Report on CenterPoint Energy's 2022/2023 Integrated Resource Plan

Submitted to the IURC on September 29, 2023

**On behalf of Citizens Action Coalition,
Earthjustice, Solar United Neighbors, and Vote Solar**

Figure 1. CenterPoint C&I MPS Scenarios

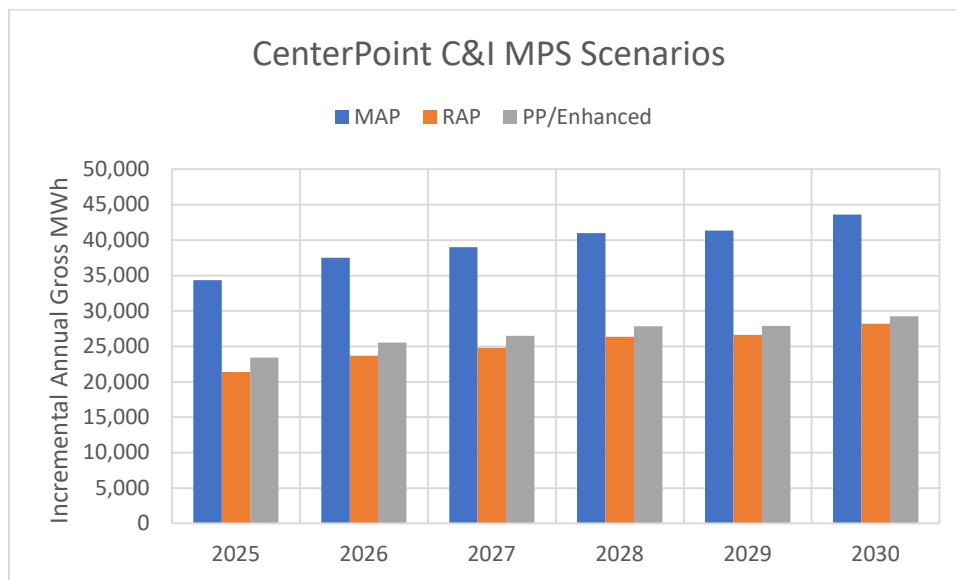
CAC appreciates CenterPoint’s responsiveness to this prior request; however, we believe the Enhanced C&I scenario falls short of achieving the goal. The savings potential is only modestly better than predicted by the RAP scenario, as shown in the figure below. Meanwhile, the levelized cost of the C&I Enhanced bundles were well below other bundles selected in the model, indicating there was room for additional incentive enhancements. For example, Figure 1 shows that the Enhanced C&I bundle has a levelized cost of \$26.07/MWh compared to Res Tier 1, which was selected at \$48.54/MWh. These issues should be addressed prior to the 3-year DSM filing.
